MCDONALD'S AT FONTAINE AND MARKSHEFFEL CONSTRUCTION DOCUMENTS VILLAGE AT LORSON RANCH FILING NO.1 LOT 2

GRADING AND EROSION CONTROL PLAN	
SHEET NUMBER	SHEET TITLE
C1.0	COVER
C1.1	GENERAL NOTES
C1.2	SITE PLAN
C1.3	SITE PLAN - DETAILS
C1.4	HORIZONTAL CONTROL PLAN
C1.5	LINE AND CURVE TABLES AND PAVEMENT
C1.6	DETAILED GRADING PLAN
C1.7	MCDONALD'S SIGNAGE AND DRIVE THRU PLAN
C1.8	MCDONALD'S SIGNAGE DETAILS
C1.9	STORM SEWER A PLAN & PROFILE
C1.10	STORM SEWER B PLAN & PROFILE
C1.11	STORM SEWER DETAILS
IR1.0	IRRIGATION PLAN
IR1.1	IRRIGATION NOTES
IR1.2	IRRIGATION DETAILS

**McDonald's at Fontaine and
Marksheffel
Village at Lorson Ranch
Filing No. 1, Lot 2
El Paso County, CO**

PCD File No. PPR2427

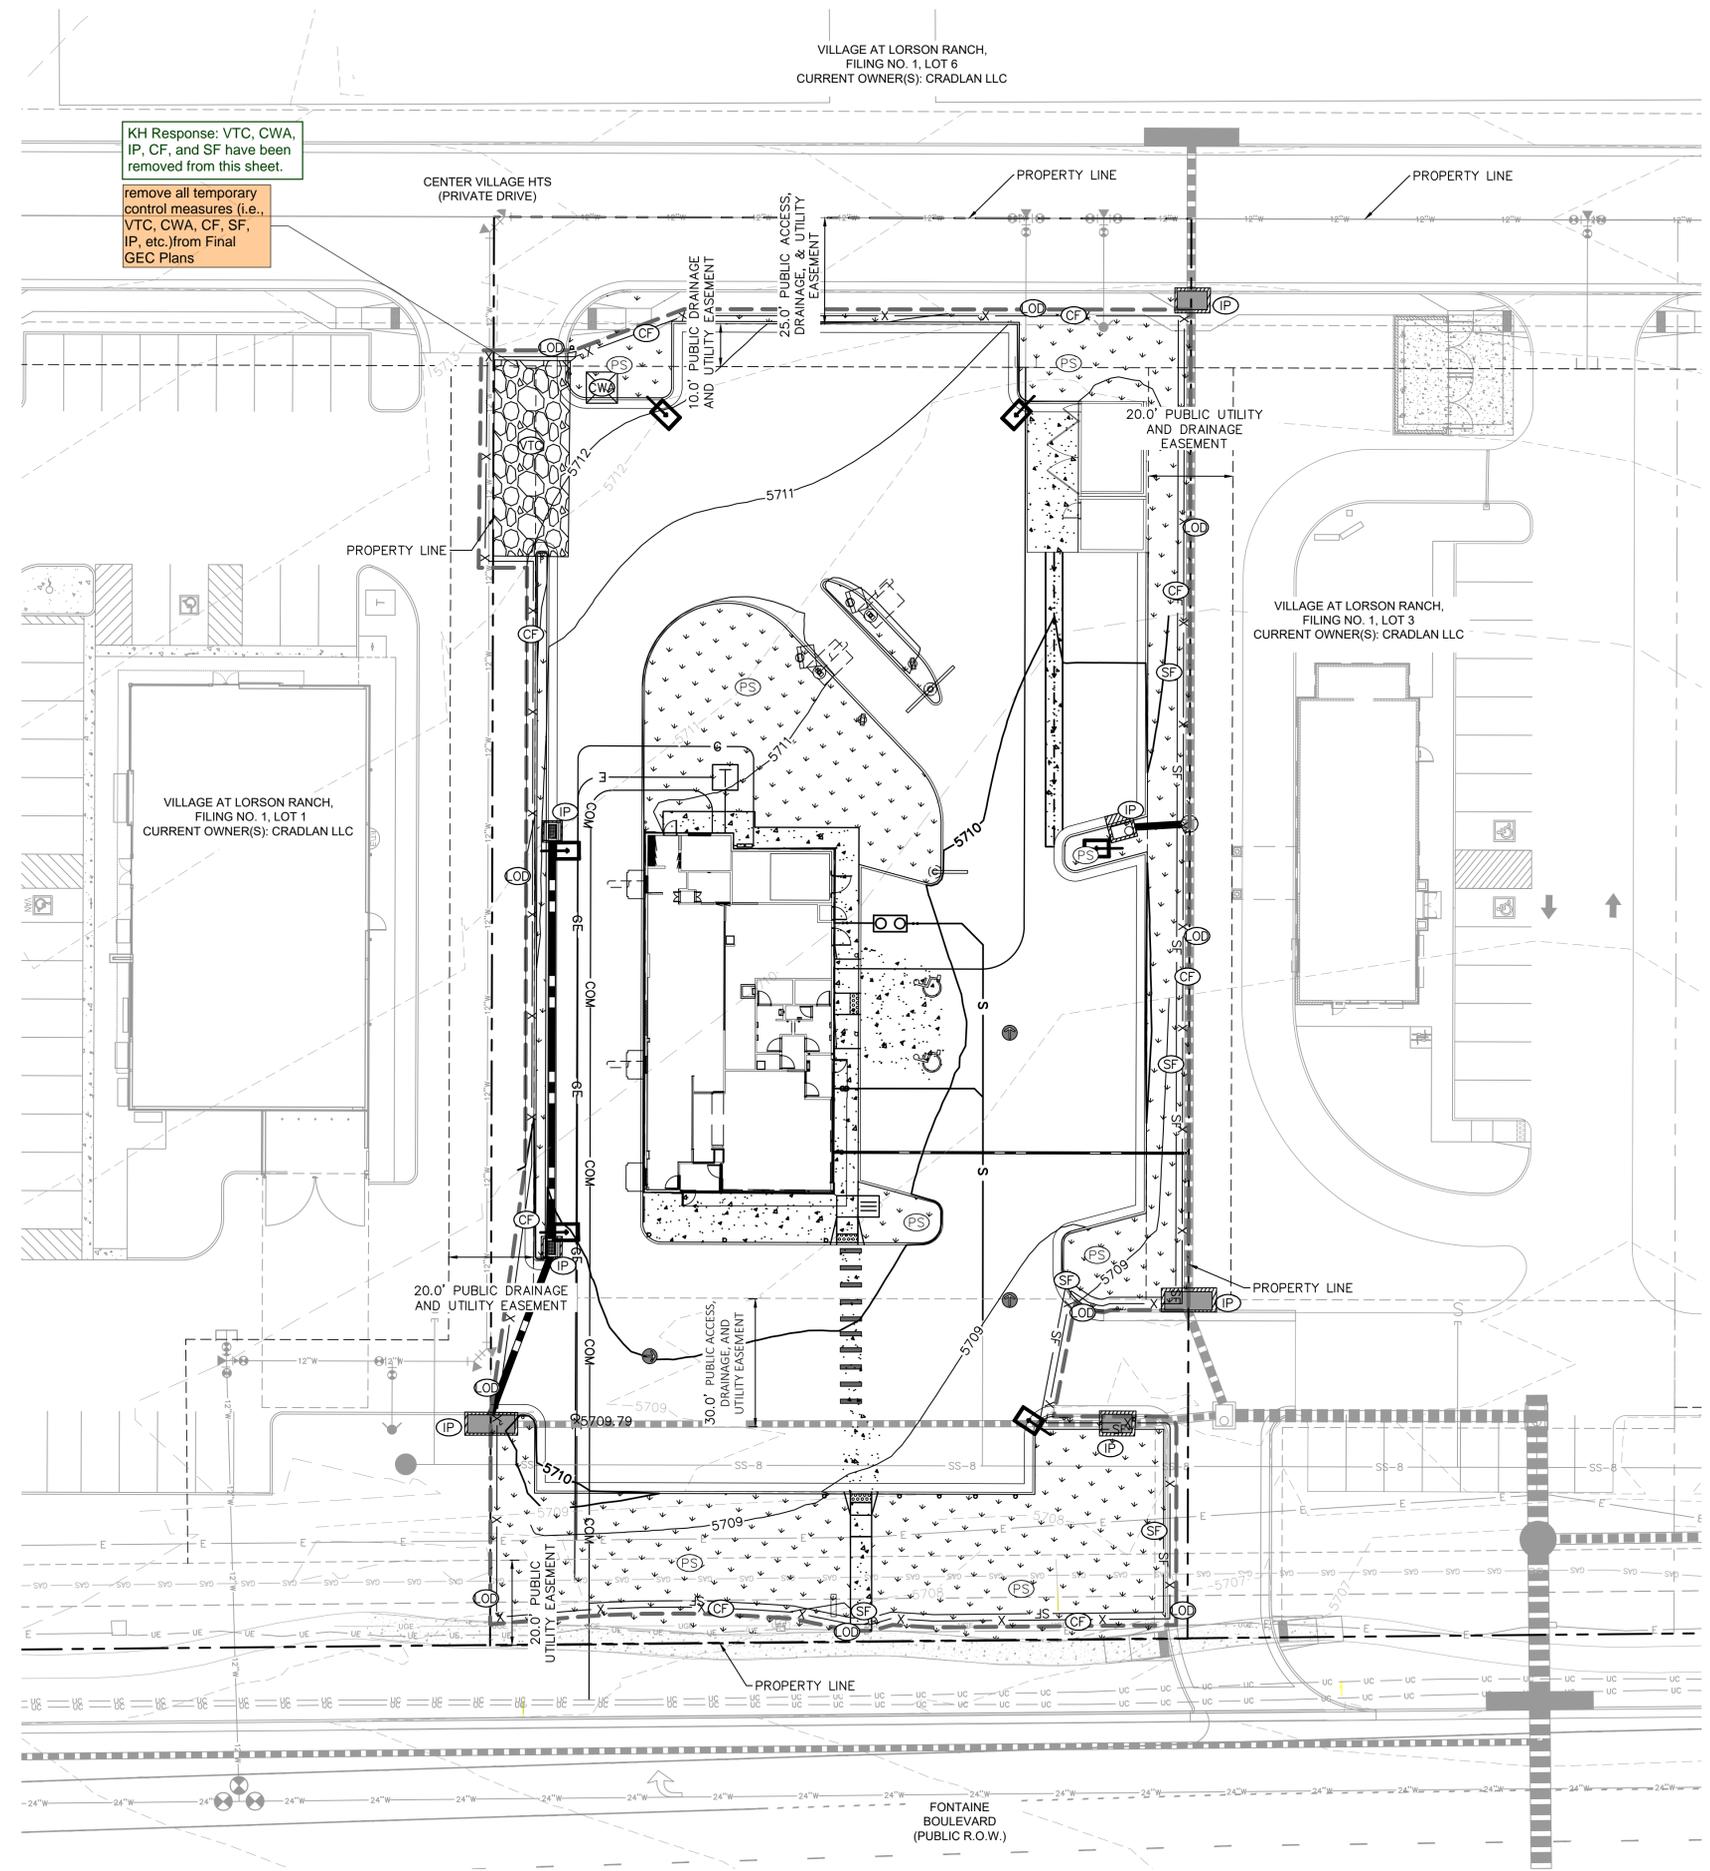
KH Response: VTC, CWA, IP, CF, and SF have been removed from this sheet.
 remove all temporary control measures (i.e., VTC, CWA, CF, SF, IP, etc.) from Final GEC Plans
